PRM-50-95  
(75FR66007)

**Subject:** Industry Comments on Petition for Rulemaking (PRM-50-95), NRC Order Vermont Yankee to Lower the Licensing Basis PCT. Docket ID NRC-2009-0554

## **Industry Comments on Petition PRM-50-95**

Figure 1 - PCT evolution of a rod due to decaying and two-sided oxidation heat assuming different cooling rates (heat transfer coefficients).

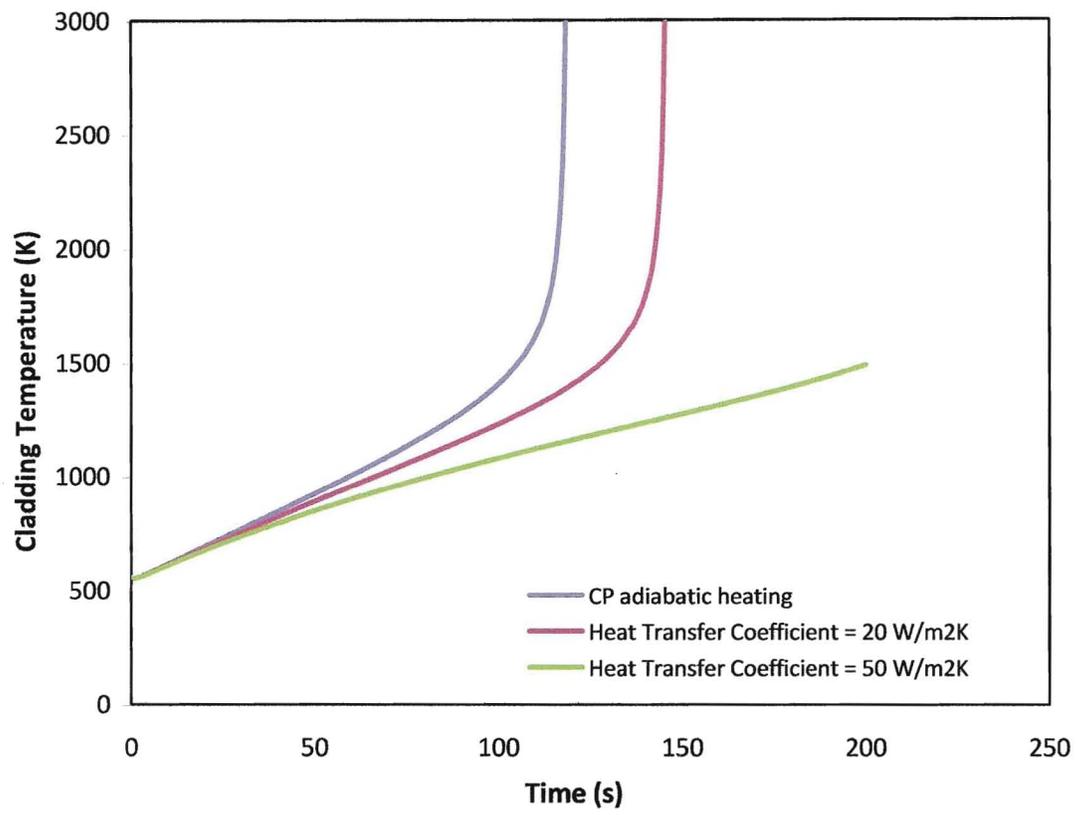
The effect of heat balance, expressed in terms of heat transfer coefficients, on accelerated oxidation is illustrated in a case study shown in Figure 1. In this evaluation, double sided Cathcart-Pawel correlation was used for the metal-water reaction. Clearly with a heat transfer coefficient of  $\sim 20$  W/m<sup>2</sup>K the reaction is autocatalytic and cannot be stopped. This is comparable to what happens in the severe accidents tests, since the test objective is to melt the rods. However, with a heat transfer coefficient of  $\sim 50$  W/m<sup>2</sup>K, a rate significantly lower than what is calculated in realistic LOCA case, the reaction is not autocatalytic and temperatures above 2200°F (1204°C) can be reached without oxidation runaway. This demonstrates that the escalation of cladding temperature is a function of the balance between heat generation and removal. This is reinforced from calculations conducted in support of the Quench-06 test [2]. The maximum calculated bundle temperatures calculated in the simulated Quench-06 experiment are presented in Figure 2. This experiment showed that with the proper heat balance it is possible for the cladding to attain high temperatures without approaching runaway oxidation (until the power transient was initiated after 6000 seconds).
